Pecan Ridge Subdivision, Unit Three,
Resubdivision of Lots 1, 2, 8, 9 and a portion of Lot 10

APPLICATION NUMBER 9 DATE October 17, 2013
APPLICANT Pecan Ridge Subdivision, Unit Three, Resubdivision of Lots 1, 2, 8, 9 and a portion of Lot 10
REQUEST Subdivision

DETAIL SITE PLAN

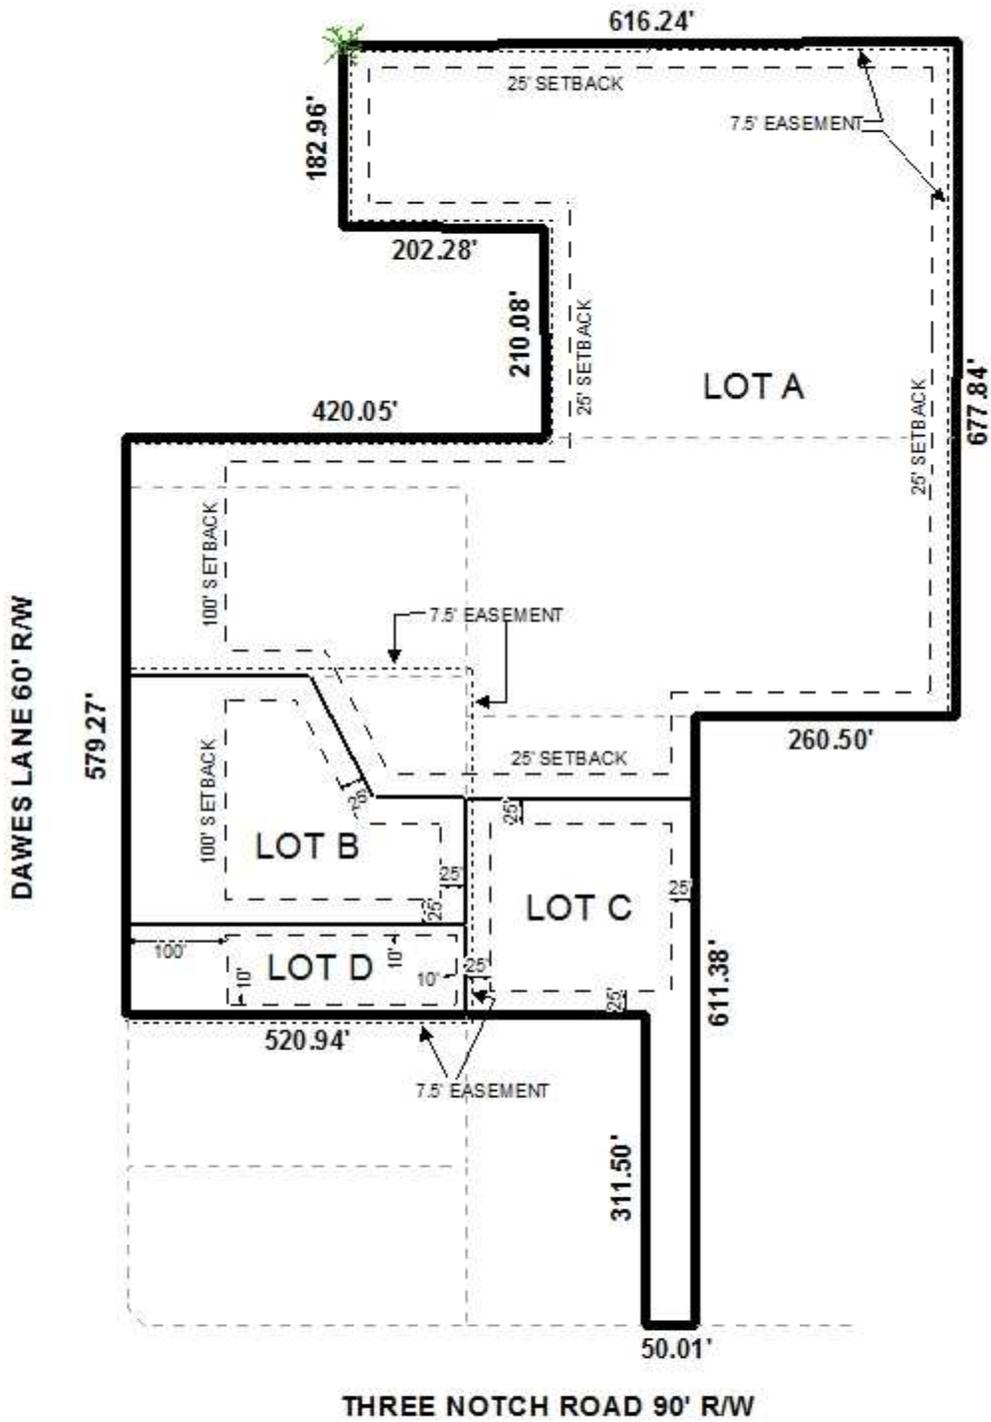
In accordance with the Subdivision Regulations, all 4 proposed lots comply with the minimum size requirements; however, the proposed Lot D will exceed the depth-to-width ratio and will require a waiver of Section V.D.3. of the Subdivision Regulations for approval. In addition, the proposed Lot C is considered a Flag Lot. The Subdivision Regulations govern lot character and Flag Lots may be permitted by the Planning Commission if in accordance with Section V.D.1.; however, the applicant has not substantiated their request by providing justification for the creation of a Flag Lot. A waiver of Section V.D.1. would be required for approval.

Also, due to the limited frontage of the proposed Lot C, a future subdivision of the proposed lot should be prohibited until additional frontage along a public or private street is provided. A note stating this condition should be placed on the Final Plat, if approved.

It should be noted that there appears to be a discrepancy in the bearing of the eastern property line of the proposed Lot C. The legal descriptions states that the boundary line runs S00°04'36"W; however, the preliminary plat depicts the property line running N00°04'36"E. If approved, the Final Plat should be revised to illustrate the correct bearings of the eastern property line.

There appears to be several 7.5' utility easements on the site. If approved, a note should be placed on the Final Plat stating that no permanent structures shall be constructed in any easement.

It should be pointed out that a 100' minimum building setback line is illustrated for the proposed Lots A, B, and D where there is frontage along Dawes Lane East. Since the proposed Lot C is considered a Flag Lot, the 25' minimum building setback line should be revised and illustrated as a box where the lot is at least 60 feet wide, which is where the "Flag" meets the "Pole" of the lot, if approved. The side yard and rear setbacks for the proposed Lots A, B, and C are depicted as 25'; however, the proposed Lot D is depicted with a 10' side yard and rear setback. It should be noted that the Subdivision Regulations do not require any side yard or rear yard setbacks.

The proposed Lots A, B, and D front Dawes Lane East, a minor street with a compliant right-of-way for minor streets with no curb-and-gutter and as a result, no dedication is required. The proposed Lot C has frontage along Three Notch Road, a future major street, as defined by the Major Street Plan. The preliminary plat depicts an existing right-of-way of 90'; however, in compliance with the Major Street Plan component of the Comprehensive Plan, the minimum right-of-way should be 100'. As a result, dedication to provide 50' as measured from the centerline of Three Notch Road is required and should be illustrated on the Final Plat, if approved. The lot size information for the proposed Lot C should also be revised on the Final Plat to reflect dedication, if approved.

Access management may be a concern for the proposed Lot C as it fronts Three Notch Road. Typically, each lot is allowed its own curb-cut; however, within 65' ± directly East of the location where a proposed curb-cut would be allowed, there are 2 existing curb-cuts for the 2 adjacent lots. An additional curb-cut to that section of road may cause access management issues as there would be 3 curb-cuts within 65' ± of each other on the same side of the street.

Lots A and B have one existing curb-cut each along Dawes Lane East. As a means of access management, if approved, notes should be placed on the Final Plat stating that Lots A and B should be limited to the existing curb-cuts, Lot D should be limited to one curb-cut along Dawes Lane East, and Lot C should be limited to one curb-cut along Three Notch Road with the size, design and location of the additional curb-cuts along with any changes to the existing curb-cuts to be approved by Mobile County Engineering and comply with AASHTO standards.

It should be noted that GIS data indicates the presence of wetlands on the eastern portion of the proposed Lot A. The existence of wetlands would indicate that the area may be environmentally sensitive; therefore, if approved, any development of the site must comply with local, state and federal regulations regarding wetlands. A note regarding this requirement should appear on the Final Plat, if approved.
